Comment Letter 38 – Gabrielle Watson

Response to Comment Letter 38 – Gabrielle Watson

Comment Letter 39 – Mark Newhall

Response to Comment Letter 39 – Mark Newhall

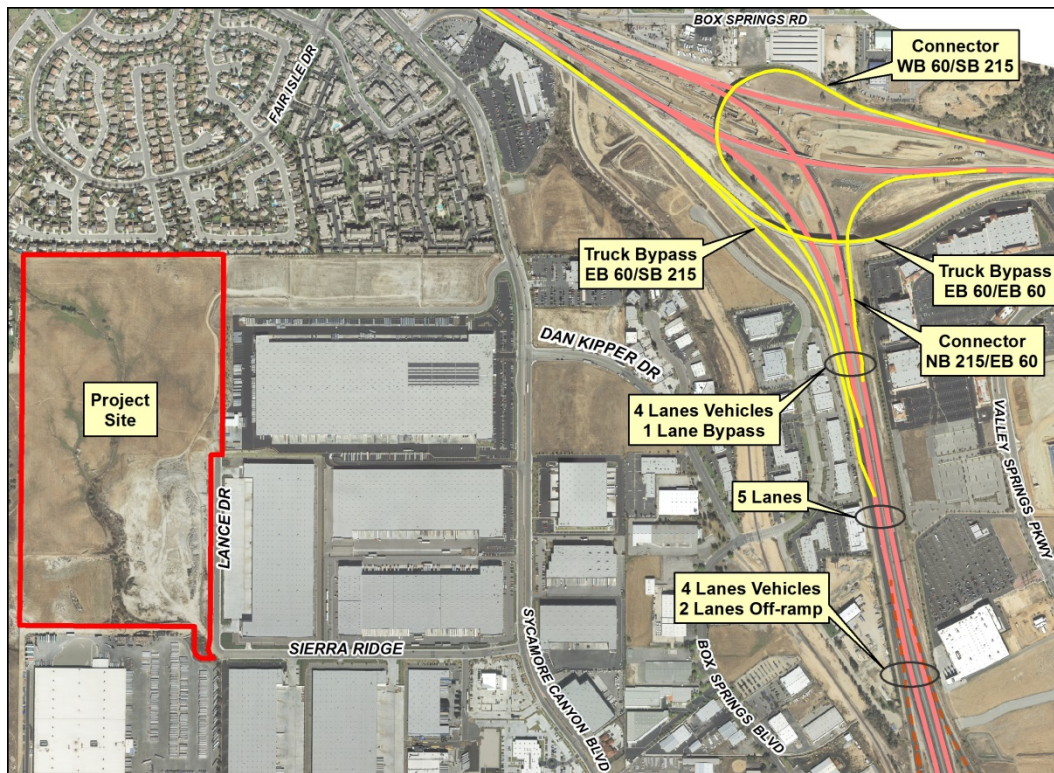
The commenter's observation regarding truck traffic is noted; however, these existing trucks are not related to the proposed Project.

The *Revised Traffic Impact Analysis for the Sycamore Canyon Industrial Buildings 1 and 2* (the TIA) indicates that approximately 95 percent of the trucks traveling to and from the Project site are anticipated to utilize the Eucalyptus Avenue exit from Interstate 215 (I-215), without travelling on Lochmoor Drive. (See DEIR **Figures 5.16-5 – Project Trip Distribution (Trucks – Outbound)**, and **5.16-6 – Project Trip Distribution (Trucks – Inbound)**). It should be noted that Municipal Code Chapter 10.56 restricts truck over 10,000 pounds from using Lochmoor Drive.

49-B

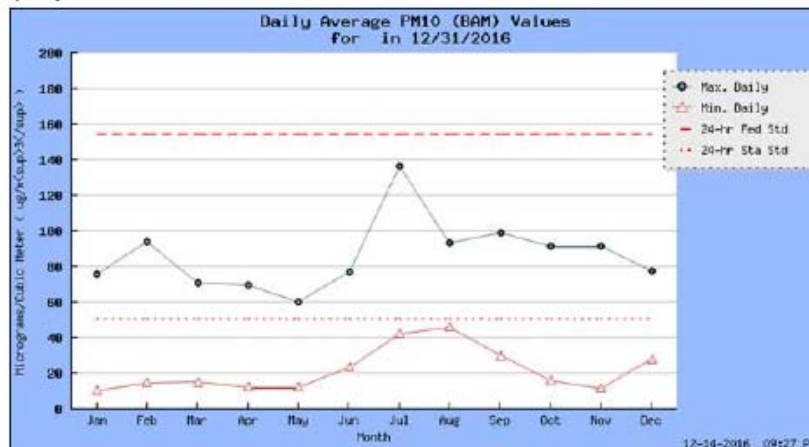
In the City Planning Commission official response to residents regarding the significant and unavoidable impact:

"Although there will be significant and unavoidable impacts related to air pollution and noise, even with feasible mitigation incorporated, the City has discretion to approve a Statement of Overriding Considerations and move forward with the Project. Section 15093(a) of the State CEQA Guidelines requires the City to balance, as applicable, the economic, legal, social, technological, or other benefits, of the proposed Project against its unavoidable environmental risks in determining whether to approve the Project. If these benefits outweigh the unavoidable adverse environmental effects, the City may consider the
